Illustrated part list IPL update

Husqvarna Division; Handheld

H555

1. Air filter

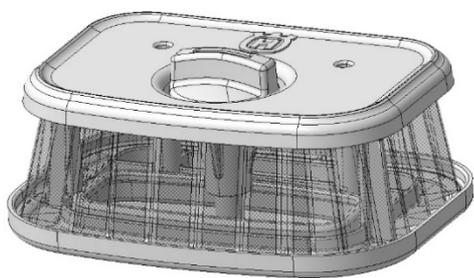
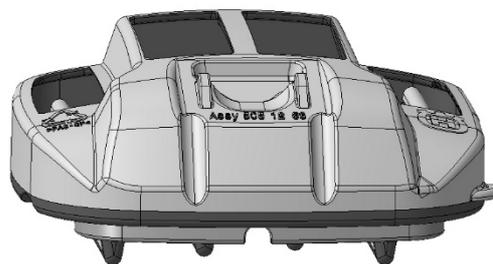
1. New improved design of air filter holder and air filter have been introduced.
2. We have introduced a new Cylinder cover assy 587 24 87-03 to fit the new filter solution. The new Cylinder cover is higher than the old one.
3. Two new Filter unit kits have been added, if users want to update old chain saws to the new Filter system.
598 93 45-01: New filter 25 µm 590 45 88-02 + New Filter holder 597 27 55-01.
598 93 47-01: New filter 25 µm 590 45 88-02 + New Filter holder 597 27 55-01 + New Cylinder Cover 587 24 87- 03.

1. Filter holder assy 597 27 55 and air filter assy 590 45 88 are NOT exchangeable.
2. Cylinder cover assy is fully exchangeable. New cover fits on old saws.

590 45 88-01/-02/-03

505 12 63-04/-05/-06/-07
